UNITED STATES PATENT AND TRADEMARK OFFICE

APPLICATION NO.	FILING DATE	FIRST NAMED INVENTOR	ATTORNEY DOCKET NO.	CONFIRMATION NO.
10/763,044	01/22/2004	Olivier Pizzuto	02-RO-250	3798

Office Action Summary

DETAILED ACTION

FIG. 2C (PRIOR ART)

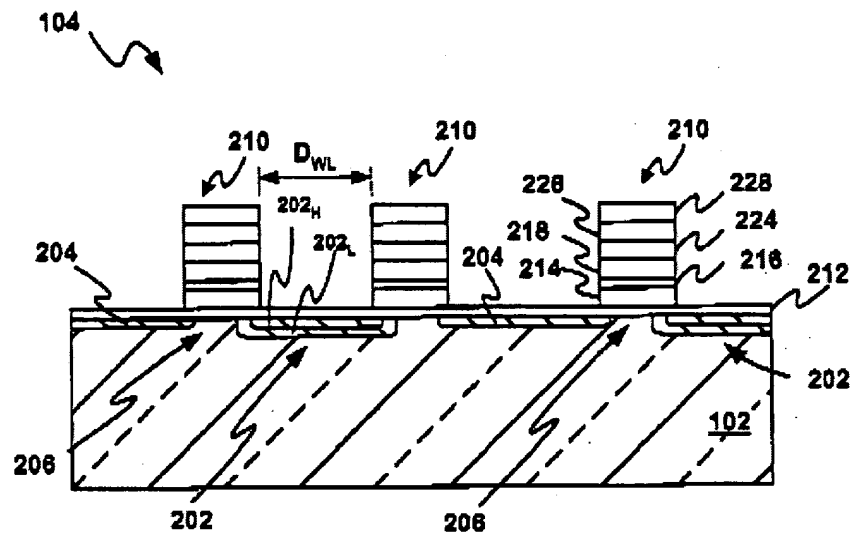
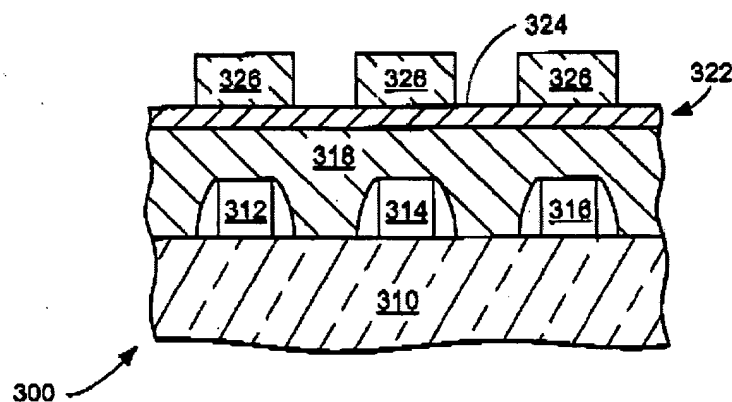
Subramanian discloses a method for flash memory process as claimed. **See all FIGS**, where Subramanian teaches the following claims.

Pertaining to claim 1, Subramanian discloses a method for producing a flash memory comprising:

forming at least two adjacent rows of precursor stacks of floating gate transistors **214** on a semiconductor substrate **102**, with the precursor stacks **210** being at least partially covered by a protective resin **212 & 318** and being separated by a formation zone for a source line **202** ;

forming a trench **202** in the formation zone for the source line **202** by an attack of the formation zone and of the protective resin **212 & 318** so as to result in a deposit of residue from the protective resin below the precursor stacks (**Column 7 lines 26-29, please note the claim 1 directly refers to self-aligned source etching process**);

removing the deposit of residue deposit (**column 2 lines 30-34**);

and implanting a source line **202** in the formation zone below the precursor stacks
(column 7 lines 36-52, please note Subramanian teaches to form source and
common line CS).
